LEGEND (ALL CHANGES TO ALL LEVELS)

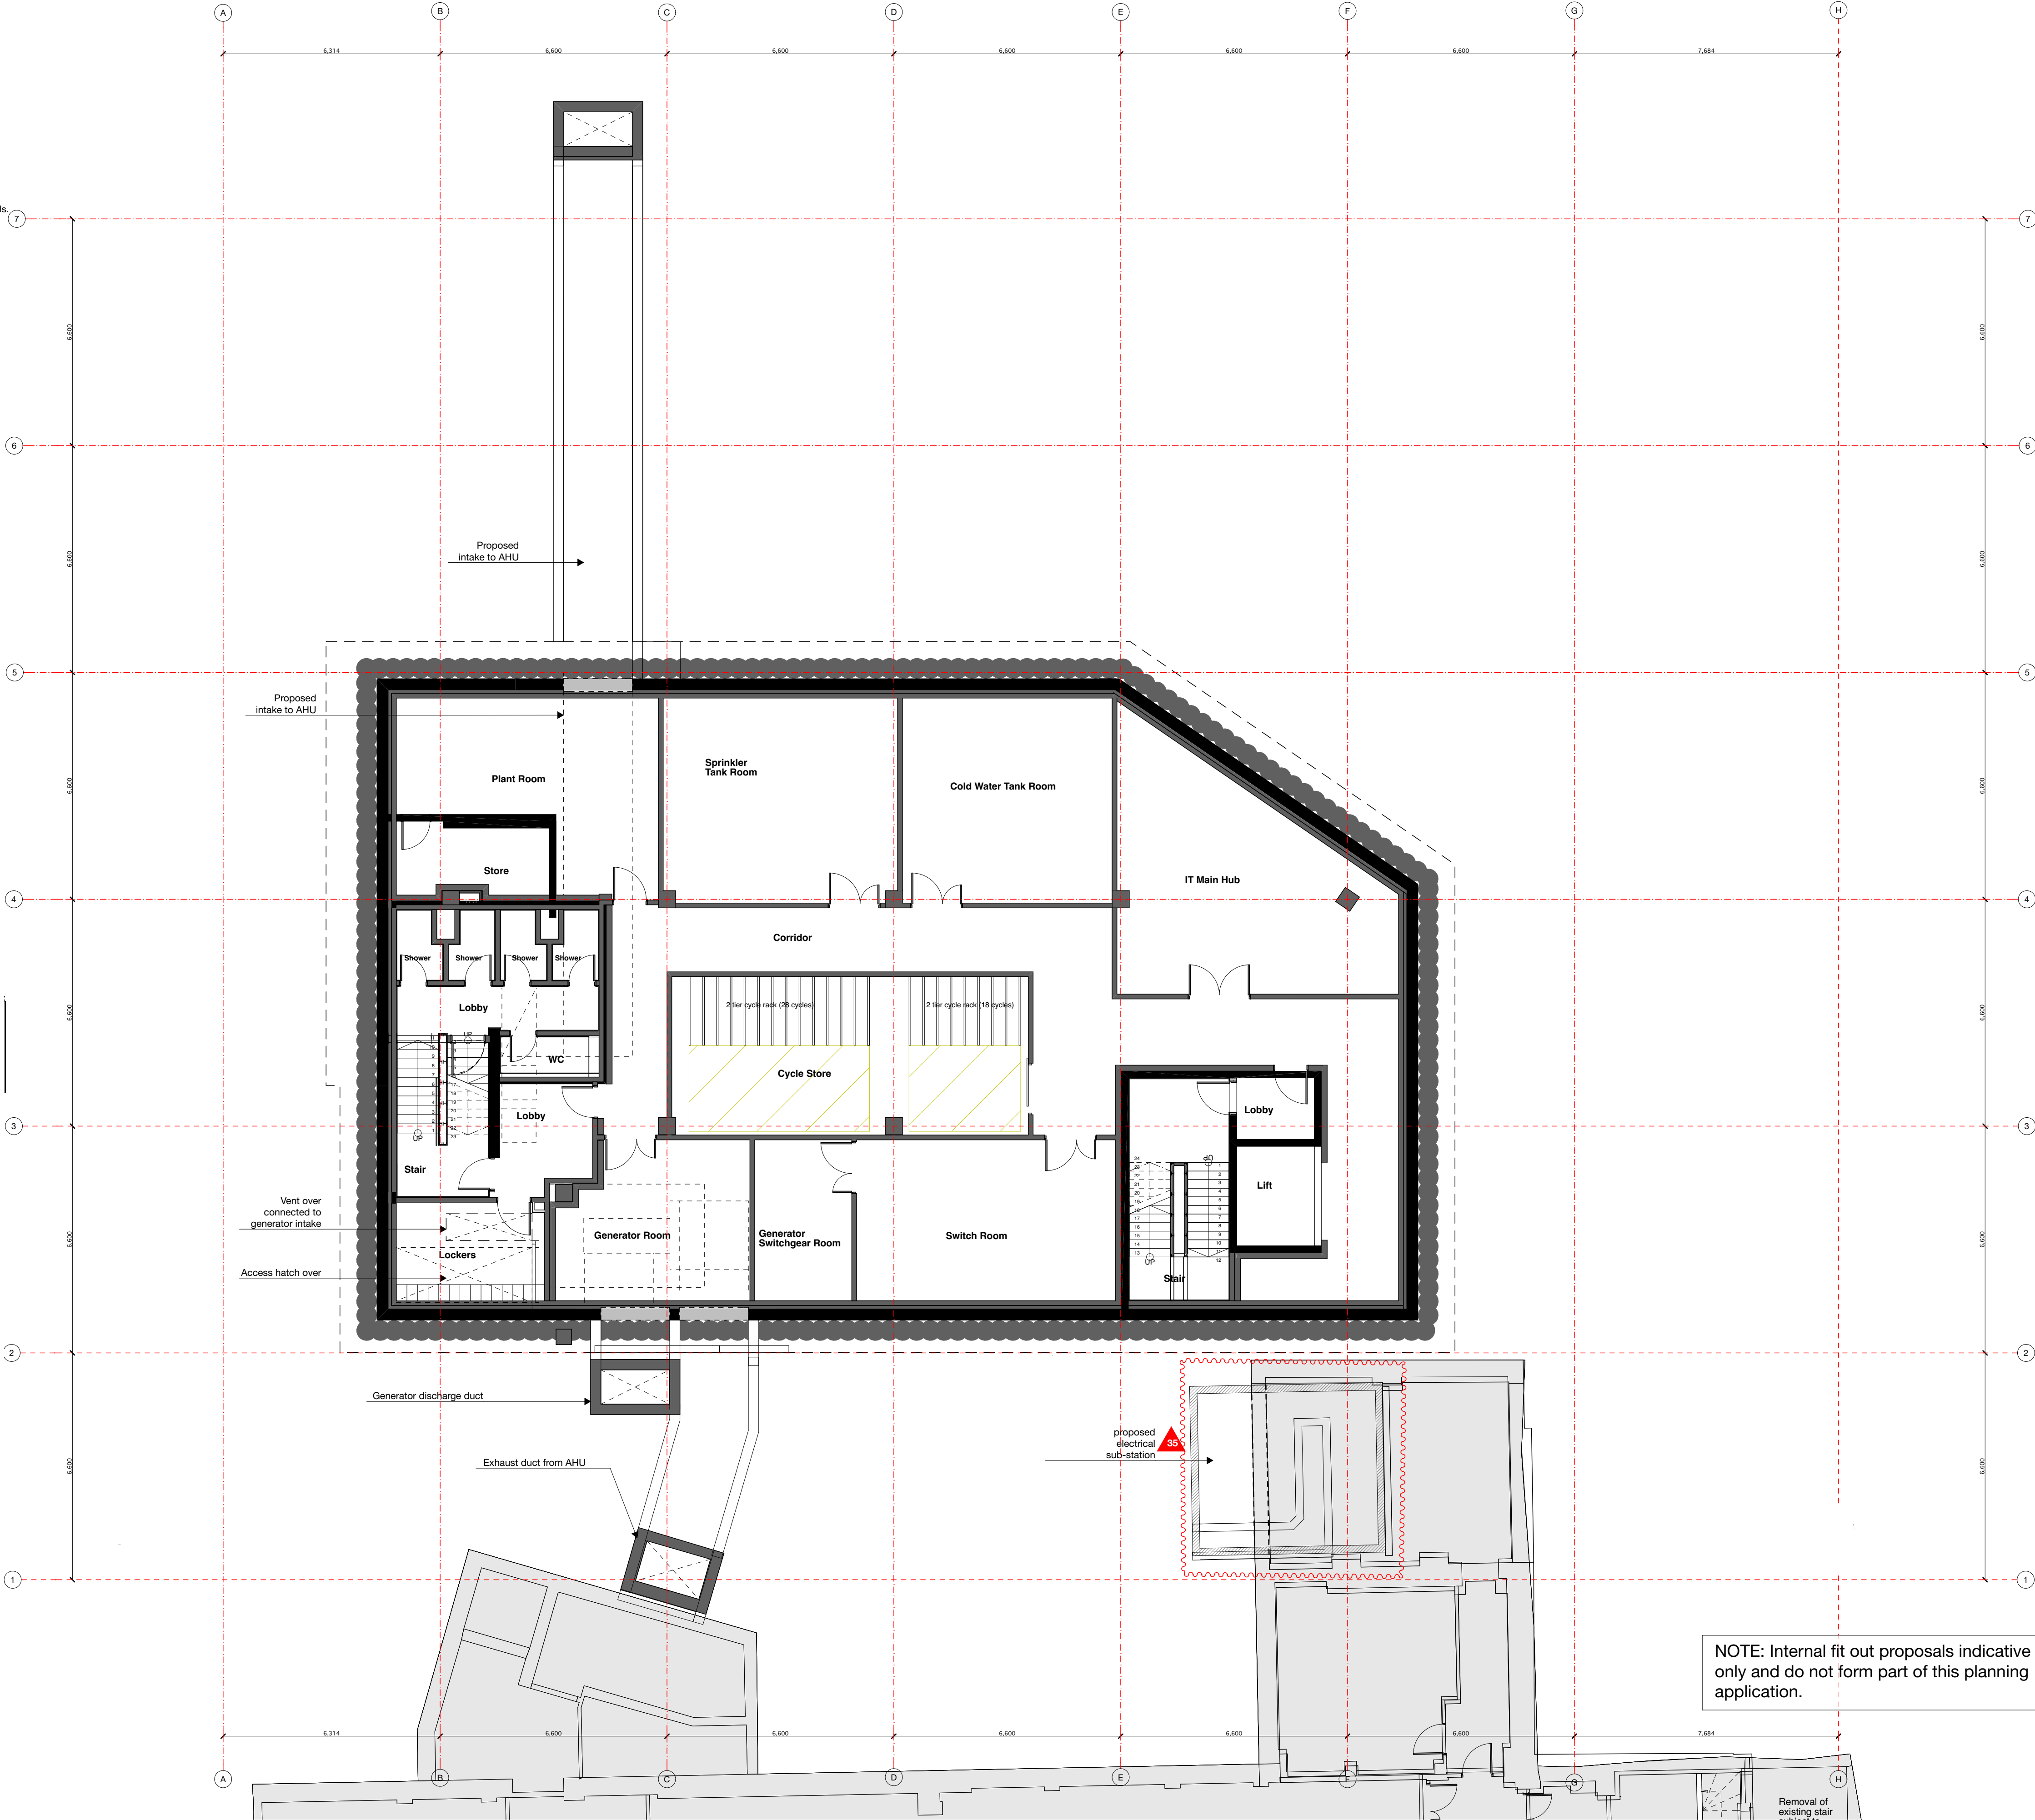
- 01. Stair 2 omitted, and glazed entrance enclosure enlarged
- 02. Window added
- 03. New steps to base of external spiral stair
- 04. Stair 3 roof and gable end arrangement revised.

- 05. Level 3 accommodation mansarded
- 06. Roof light size, height and position adjusted, and smoke vents added.
- 07. Louvres omitted.
- 08. Roof light size, height and position adjusted.

- 09. External ramp adjusted, and railings added.
- 10. West stair core glazing fenestration adjusted to suit amended stair landing levels.
- 11. External paving levels in courtyard raised to achieve required paving falls.

- 12. Low brick plinth added to base of external walls to TP2.
- 13. Brick plinth added to base of existing buildings within courtyard.
- 14. New steps and landing outside room G1.

- 15. Bin store enlarged and repositioned.
- 16. Gallery passageway to TP2: finishes revised.
- 17. Gallery passageway: entrance gates design revised.
- 18. Window on north elevation of TP2 reduced in length.

- 19. Revised turn-table size and position
- 20. Entrance ramp gradient and levels adjusted.
- 21. External levels adjusted
- 22. TP1 west door ramp omitted

- 23. Fall restraint added
- 24. Gates removed
- 25. Maintenance access door added
- 26. Parapet revised
- 27. Roof/wall shape adjusted
- 28. TP1 reception relocated

- 29. Revised door design
- 30. Modifications to windows, doors and facades facing into courtyard.
- 31. Gate details revised
- 32. Revised proposal for bike storage replacing existing bike racks in Dairy added.

- 33. Gate retained and modified
- 34. Bike canopy detail revised (typical condition highlighted)
- 35. Sub-station & LV switch-room revised, including external doors

- 36. Steps adjusted
- 37. Cladding changed to brass finish
- 38. Wall mounted planters revised (typical condition highlighted)
- 39. Steel posts added to boundary wall (typical condition highlighted)

- 40. Height of glazed entrance roof increased to suit required pitch.
- 41. Glazed entrance roof and canopy revised
- 42. New roof guarding to existing flat roof

- 43. Screening fins and cladding added
- 44. Louvres added
- 45. Ramp omitted
- 46. Door removed and infilled
- 47. Access hatch adjusted.
- 48. Depth of green/blue roof build-up adjusted.

- 49. Blue roof incorporated into green roof and gravel margins added.
- 50. Cladding build-up adjusted
- 51. Orientation of brass seams adjusted
- 52. Roof gutters revised.

- 53. Means of escape revisited and exit door added to TP1
- 54. Spiral staircase landings added at each floor
- 55. Door modified
- 56. Basement louvers to external metal staircase landings

- 57. Revised proposal for mean of escape in TP1
- 58. Revised proposal for window and door
- 59. Revised proposal for door to be left as current
- 60. Gate to be removed

- 61. Capping width adjusted and roof planters shown indicatively.
- 62. Door to be replaced
- 63. Revised proposal for the entrance
- 64. Gates and Entrance door in TP1 to be replaced

- 65. Existing stair to be demolished
- 67. Existing window and door to be replaced
- 68. New reconfiguration for new spiral stair and WC
- 69. Staircase partially demolished

- 70. Level adjusted
- 71. Lift pit adjusted
- 72. Level updated
- 73. Red line extended to include South Crescent Mews
- 74. Red line extended to include new ramp and frontage

- 75. Ladder added
- 76. Works to Mews paving/kerbs added
- 77. Minor adjustment to ridge, and eaves line, (not affecting ridge level noted on consented drawings).
